Product Change Notification - SYST-11YPLB717

Notification subject: ERRATA - LAN8740A/LAN8740Ai - Silicon Errata and Data Sheet Clarification Errata Document Revision

Description of Change: Rev A replaces the previous SMSC version Rev. 1.2

LAN8740A/LAN8740Ai Silicon Errata and Data Sheet Clarification

FIGURE 1: TOP MARKING FOR FUNCTIONAL REVISION A DEVICE

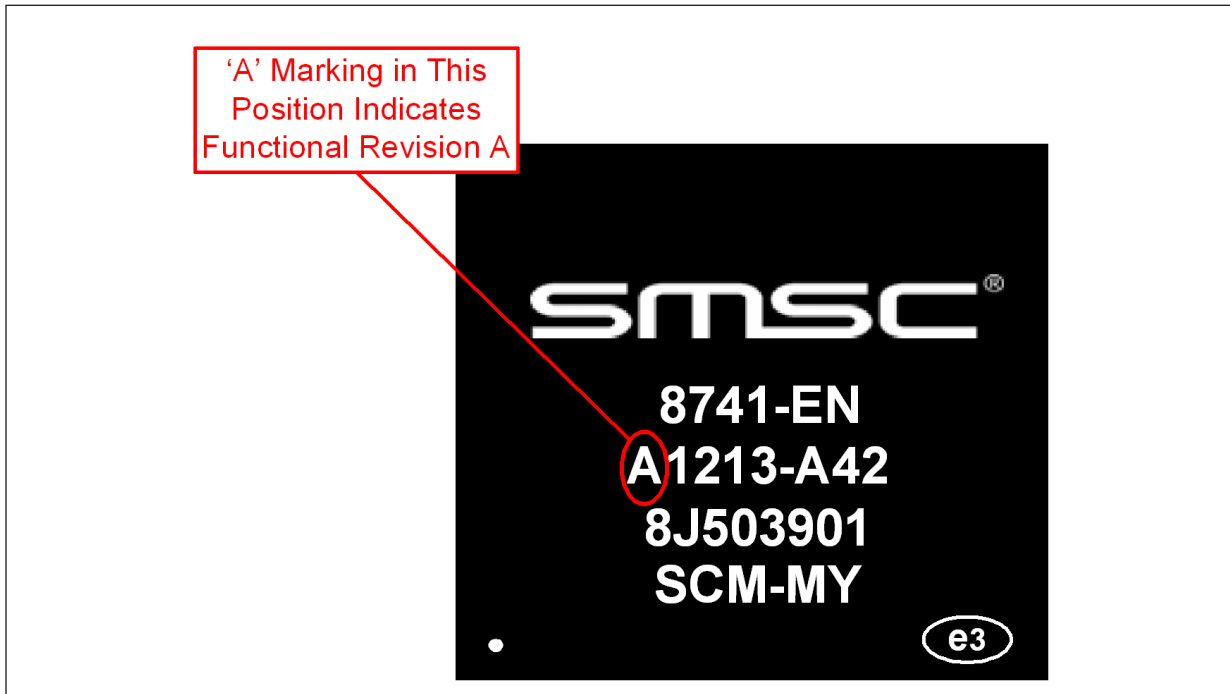
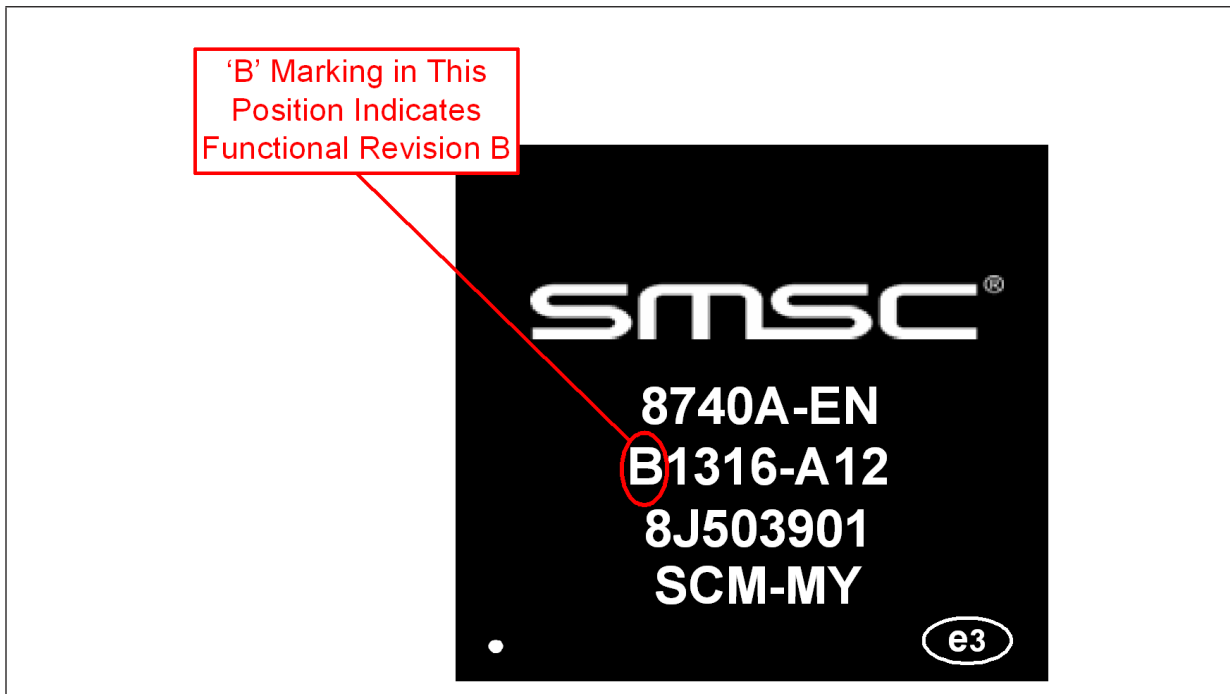
This document describes known anomalies for functional revision A and B of the LAN8740A/LAN8740Ai device. The functional revision can be determined by its top marking as indicated in [Figure 1](#) and [Figure 2](#).

For the purposes of this anomaly sheet, the part number indicated throughout the document includes an "A". Though only functional revision B parts contain an "A" in the device part number, this anomaly sheet also applies to the LAN8740 parts. The "A" in the part number is not indicative of the functional revision. Refer to [Figure 1](#) and [Figure 2](#) for the proper identification of the functional revision of a given device.

FIGURE 3: EXAMPLE EXTERNAL CRYSTAL CIRCUIT

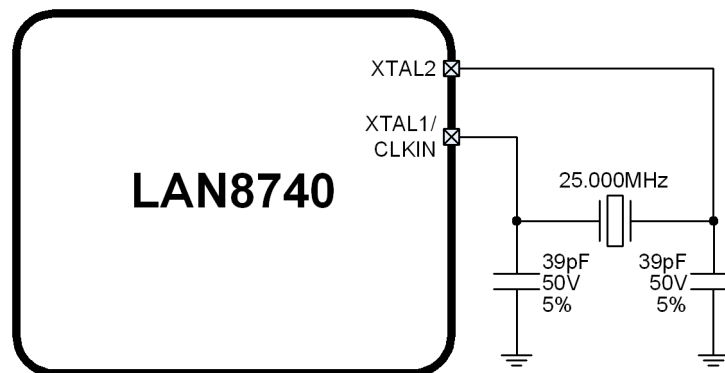
In EEE mode, the device may drop link when using a Broadcom BCM53125 link partner at cable lengths less than 20 meters.

When using a Broadcom BCM53125 link partner in EEE mode, the device may drop link when using cable lengths less than 20 meters. The BCM53125 has exhibited a sensitivity to minute deviations in its link partner's transmit clock frequency during 100Mb EEE operation. This issue is exacerbated at short cable lengths. This anomaly does not impact 10Mb or non-EEE operation.

1. Utilize an Ethernet cable length of greater than 20m.
2. Increase the load capacitors on the LAN8740A/LAN8740Ai external crystal circuit to 39pF and exercise best practices for board layout. Refer to [FIGURE 3](#): for an example external crystal circuit.
